AUSTIN RANCH

Planned Area Development

Re: Austin Ranch (PAD 03-278)

Per approved Stipulation (b) this is a written response to the approved stipulations along with five-copies of the Austin Ranch PAD document revised to comply with the approved City Council stipulations. The following is a response to each of the stipulations approved as part of this PAD rezoning case:

Conceptual Land Use Exhibit

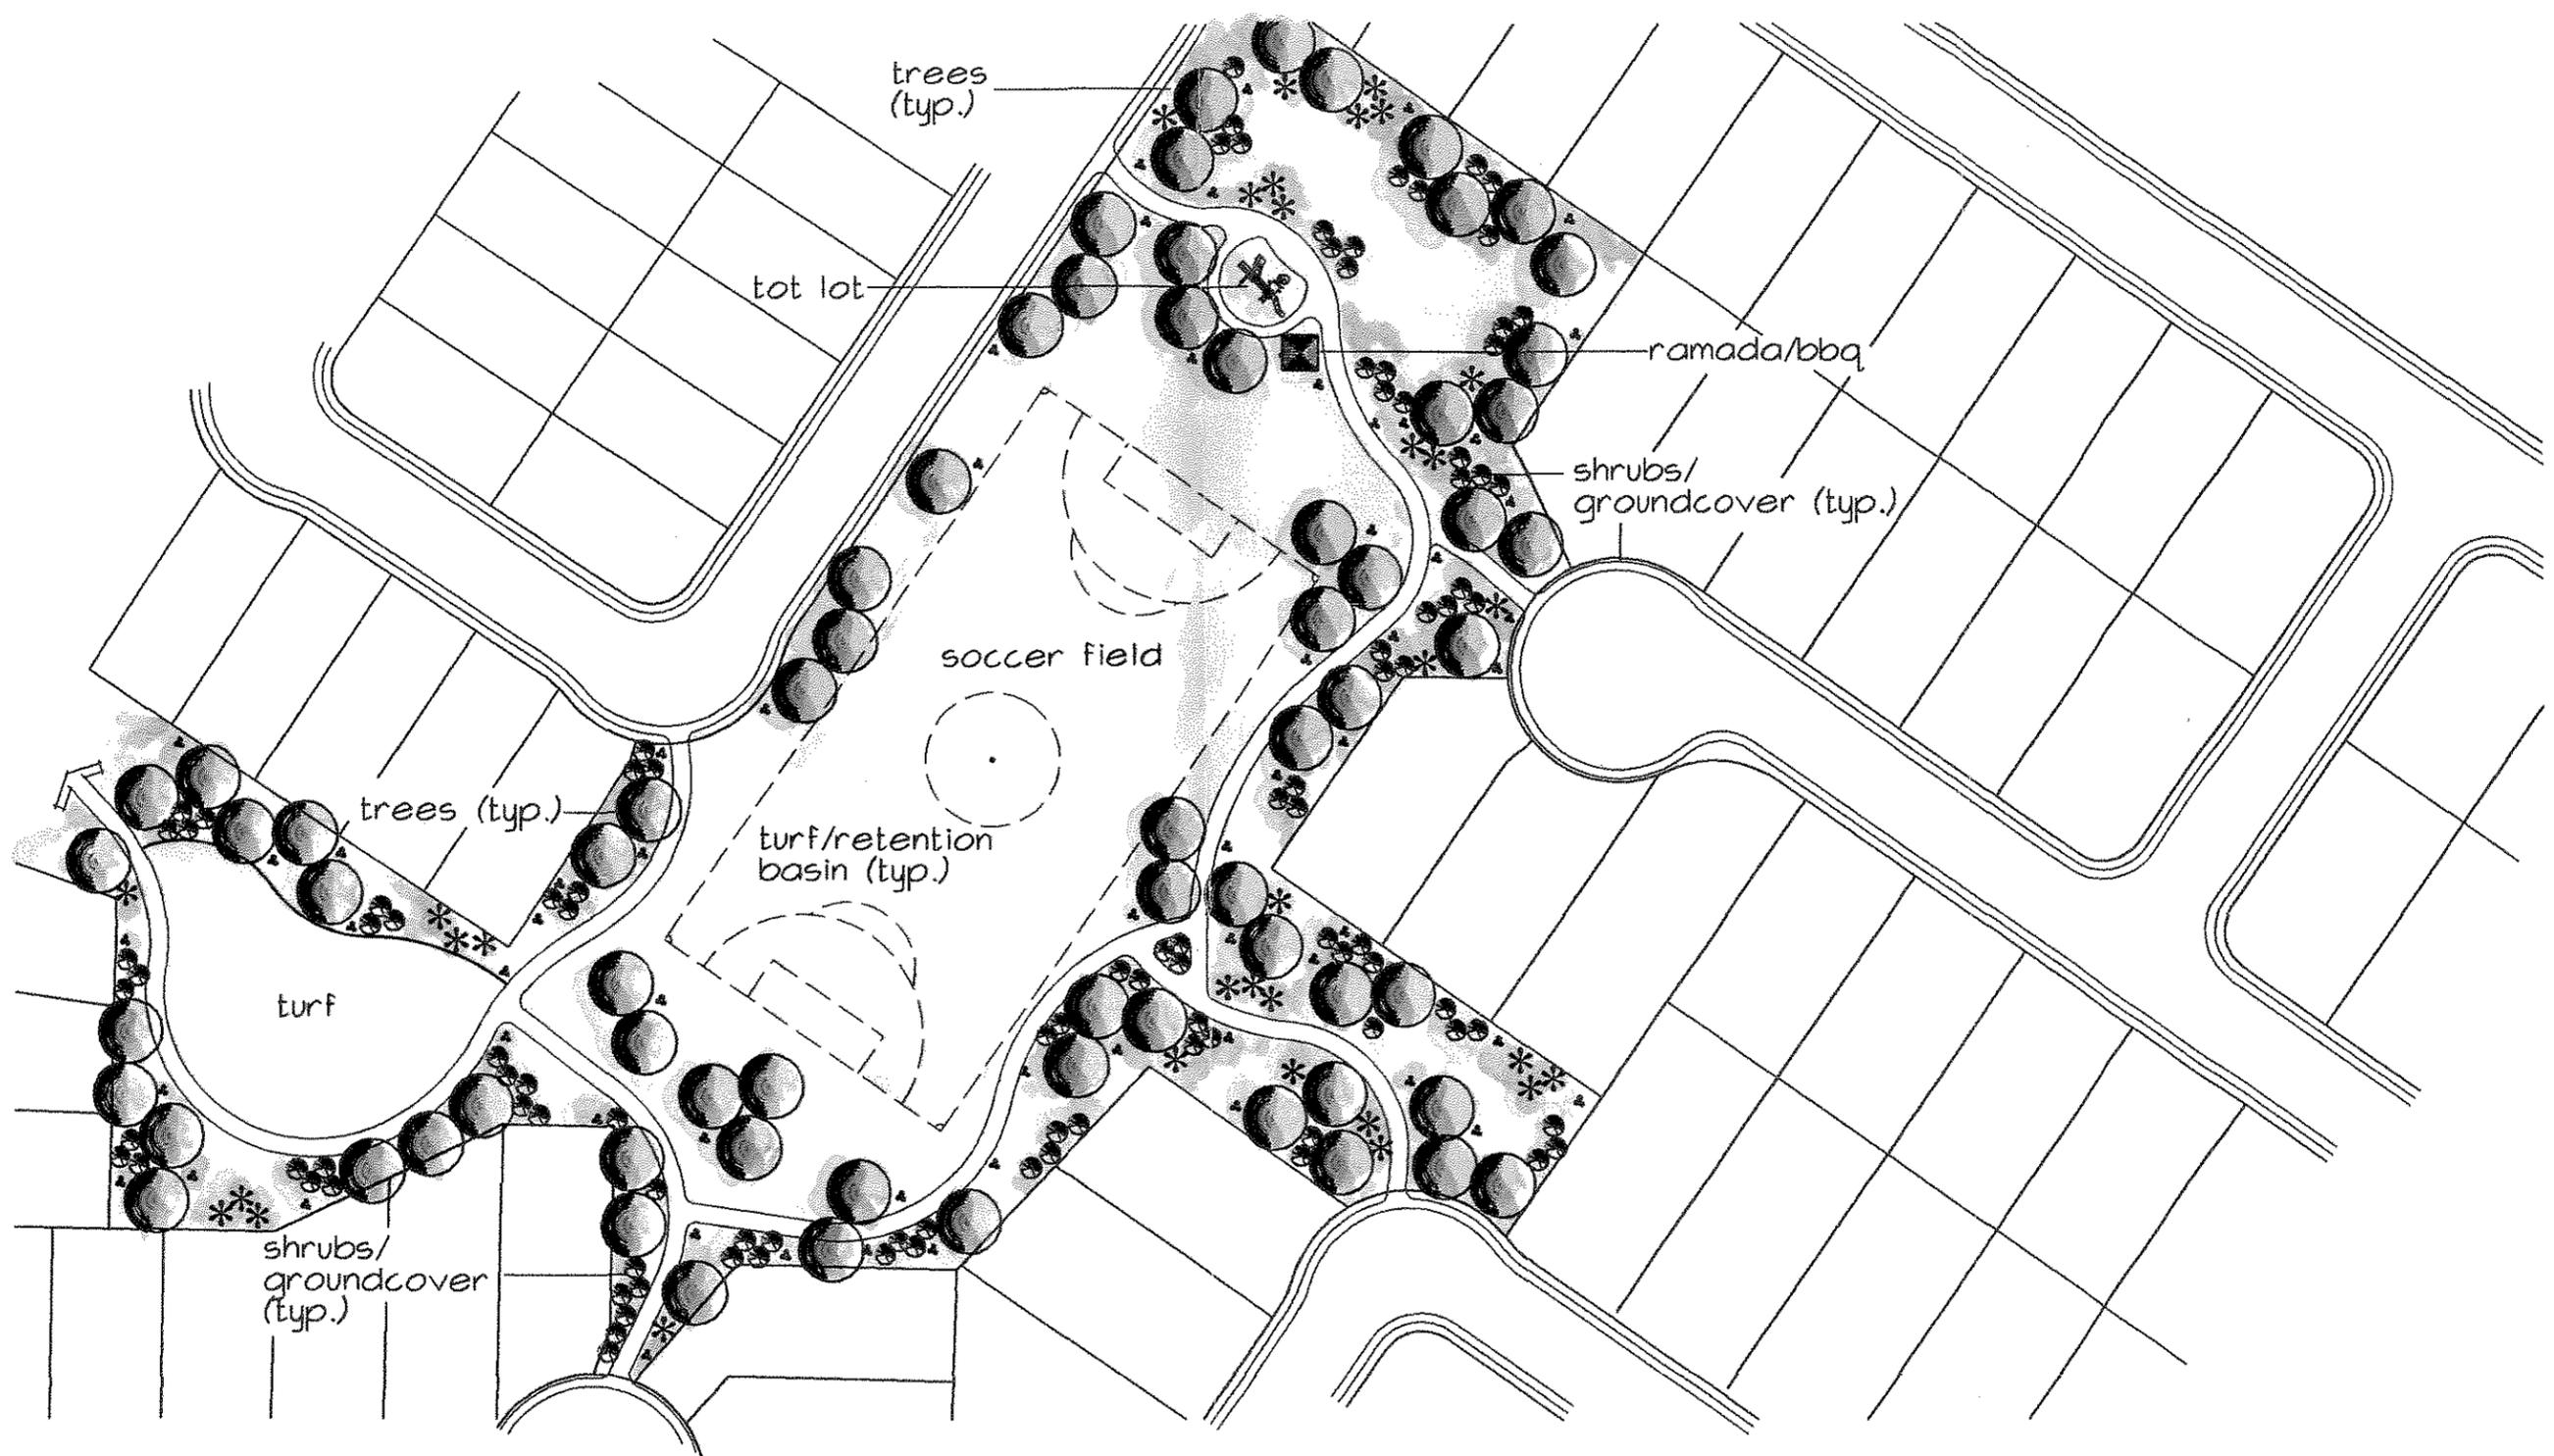
- n. The location of the school site (Parcel 5) shall be relocated east to the corner of Pinnacle Peak and Citrus Roads, and residential Parcel 4 shall be switched into the previous school site location next to the wash, the final location of the school site shall be subject to the approval of Luke Air Force Base.

The school site was relocated in the site plan as Exhibit D in the Austin Ranch PAD narrative.

Conceptual Wall Exhibit

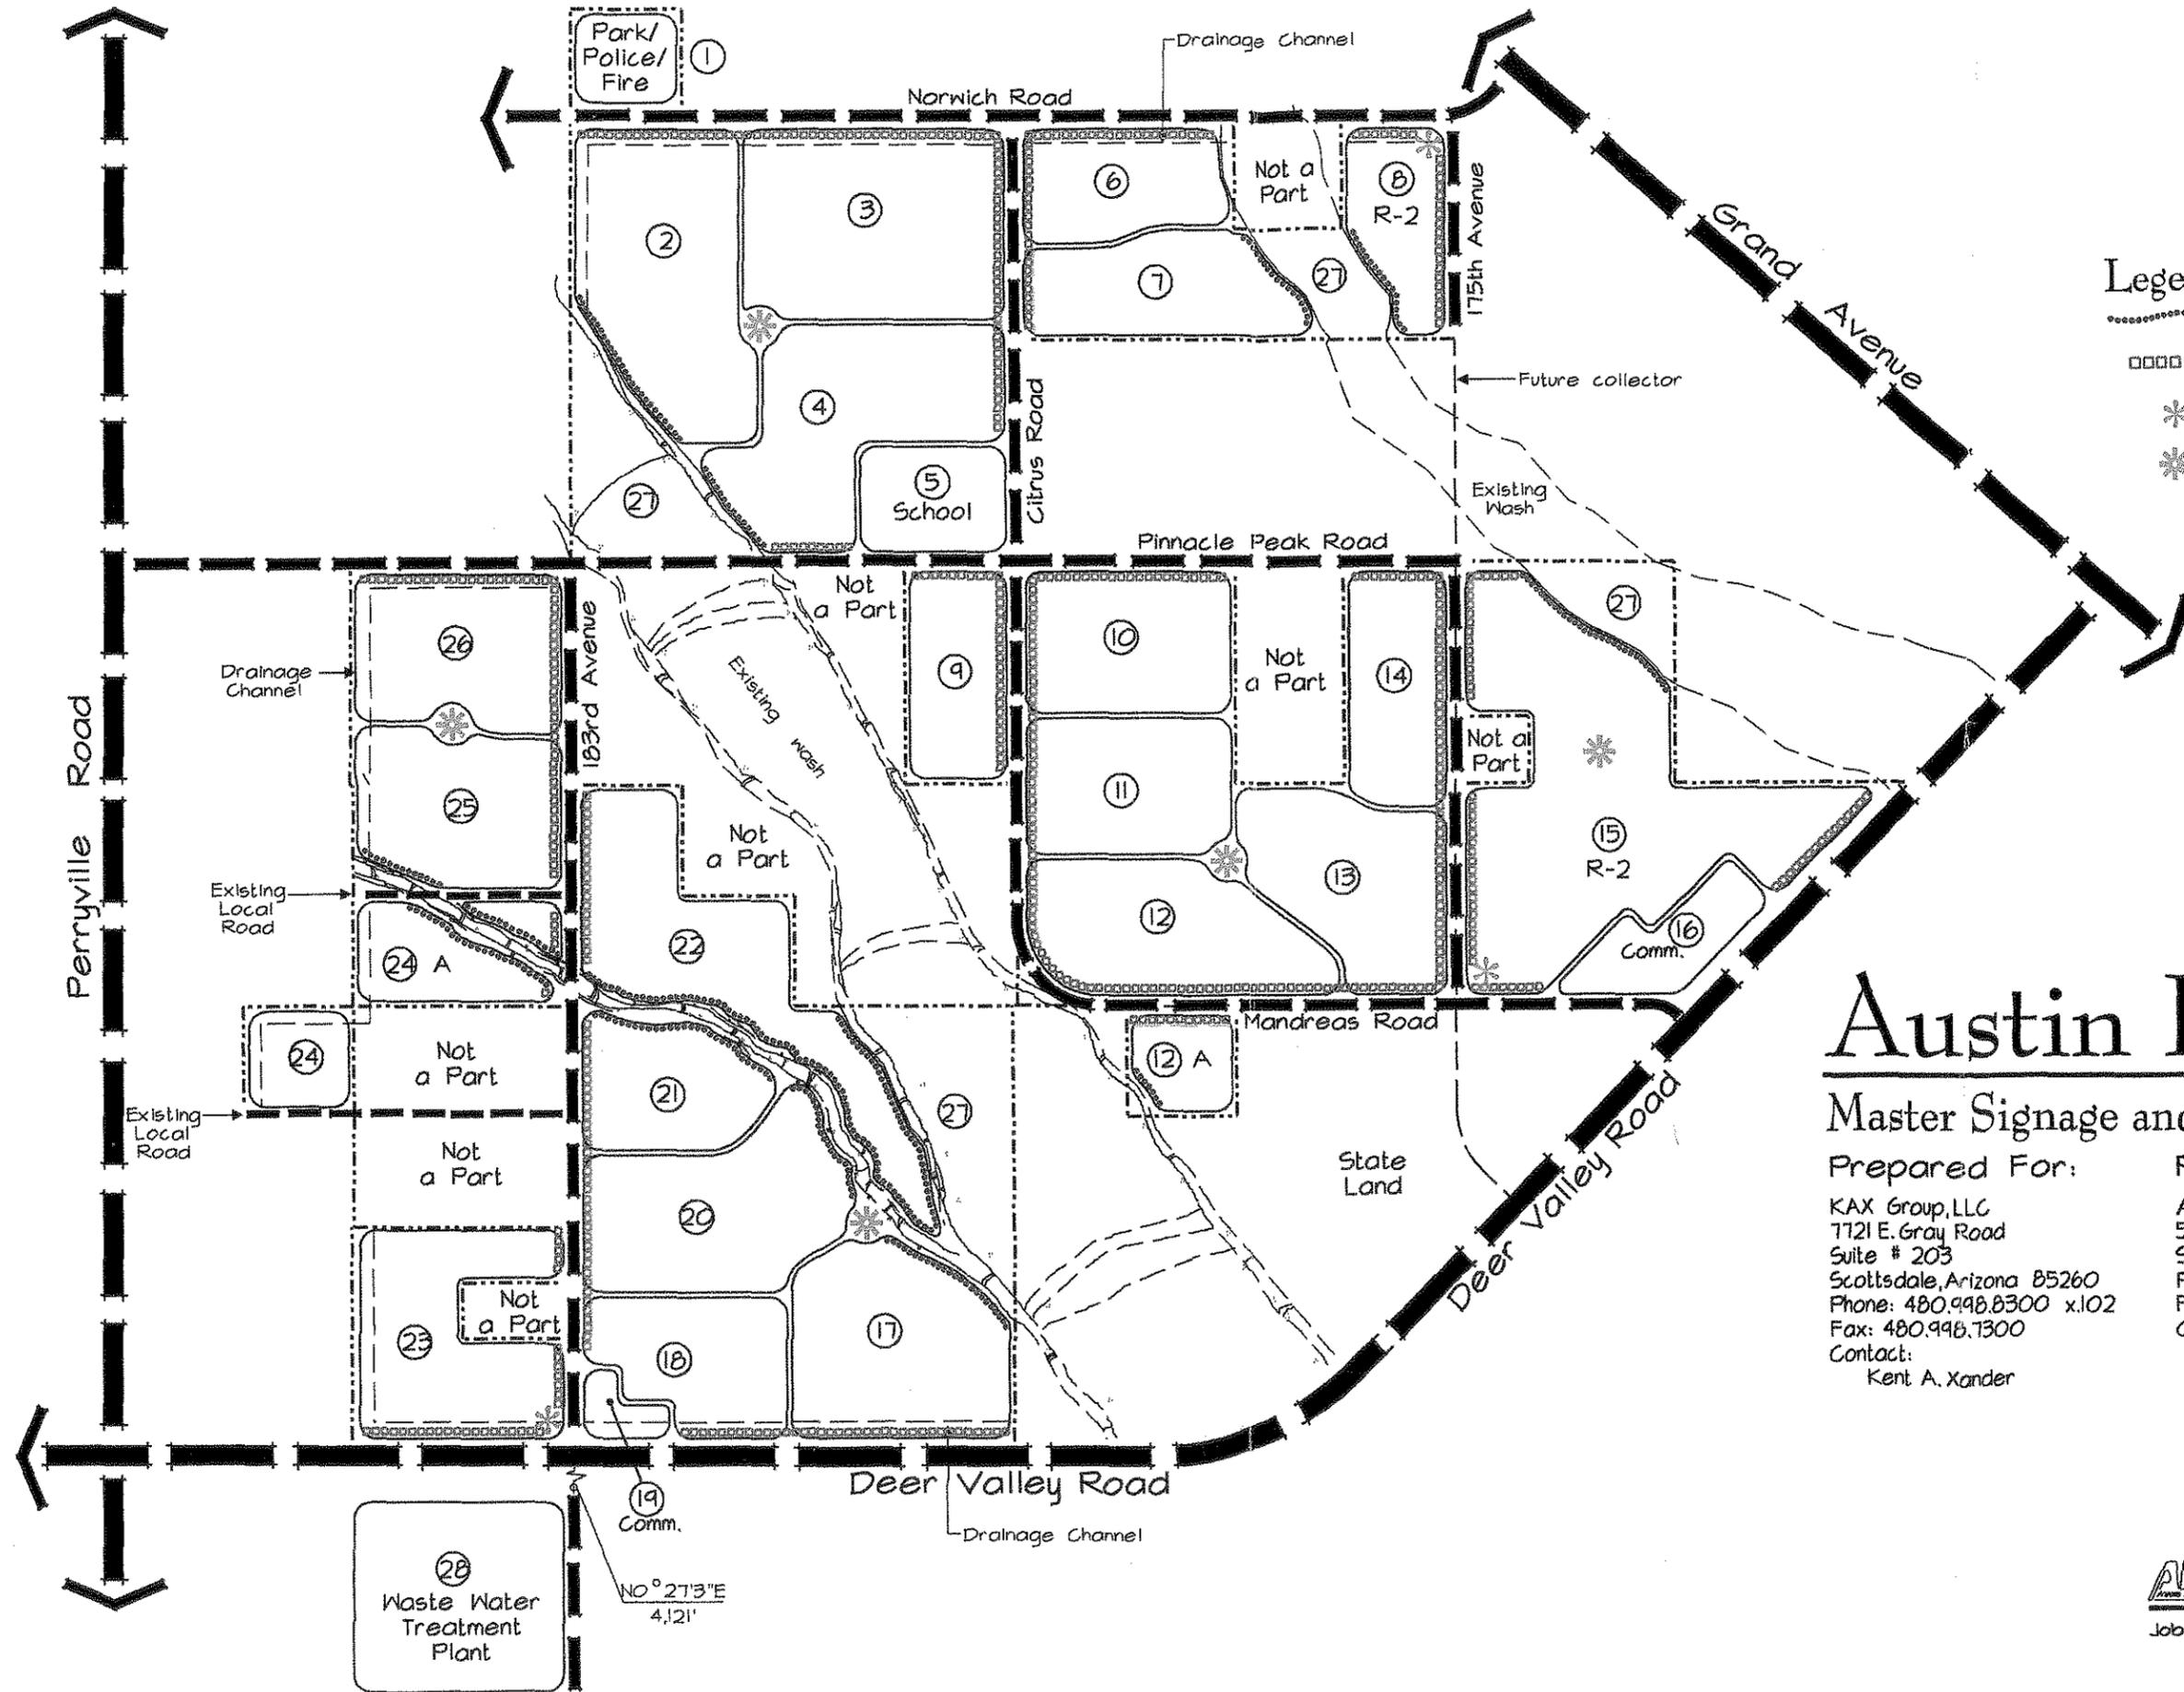
- s. The project shall incorporate alternative materials to be applied to the theme wall and theme wall, columns, and provide additional banding and insets to enhance the appearance of the project theme wall.

The applicant will work with the City to provide a common theme wall and that will be accomplished at the time of the first preliminary plat. Added to Wall Theme paragraph.
